Southern Nuclear Operating Company
Vogtle Electric Generating Plant Units 3 and 4
Revised Request for License Amendment:
Structural Design of Auxiliary Building Floors (LAR-16-009R1)

Revised Request for License Amendment Regarding
Structural Design of Auxiliary Building Floors
(LAR-16-009R1)

Proposed Changes to Licensing Basis Documents
(LAR-16-009R1)

UFSAR Subsection 3.8.4.4.1, Seismic Category I Structures – Revise to include additional information for the last paragraph as shown below.

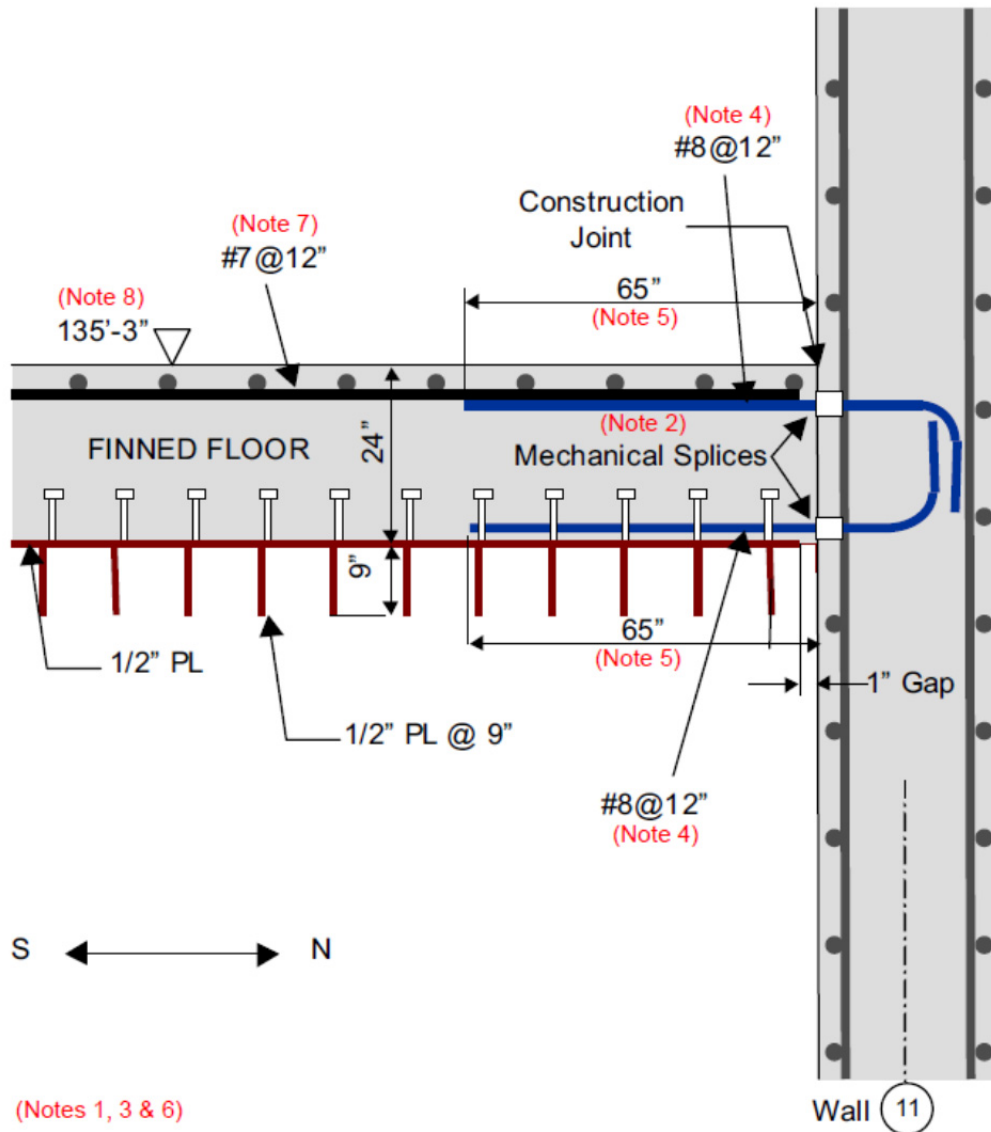
The concrete floors on steel plates, including the ~~control room ceiling and the~~ floors in the CA20 module, are designed as reinforced concrete slabs in accordance with ACI-349. The steel panels are designed and constructed in accordance with AISC-N690. For positive bending, the steel plate is in tension and the steel plate ~~and stiffeners~~ serves as the bottom reinforcement. For negative bending, compression is resisted by the concrete and ~~stiffened steel~~ plate and the tension by top reinforcement in the concrete. This methodology is similar to that described for the control room ceiling in Subsection 3H.5.4.

The information in this paragraph is specific to the CA20 connection of the floor to the wall for the concrete on steel plate floors at El. 82'-6" and El. 92'-6". The connection of the floor to the wall for the concrete on steel plate floors satisfies ACI 349 requirements in Sections 12.2, 12.15, and 21.5.4 for the development length and non-contact reinforcement bar splices. The design of the connection satisfies ACI 349, Appendix B, requirements for shear stud strength and AISC N690 requirements for shear stud capacity. The anchorage of the reinforcing dowels may vary from that shown in UFSAR Figure 3H.5-9, Sheet 2. Differences in dowel anchorage details continue to satisfy ACI 349 requirement for standard hooks and ACI 318-11 requirements for headed reinforcement.
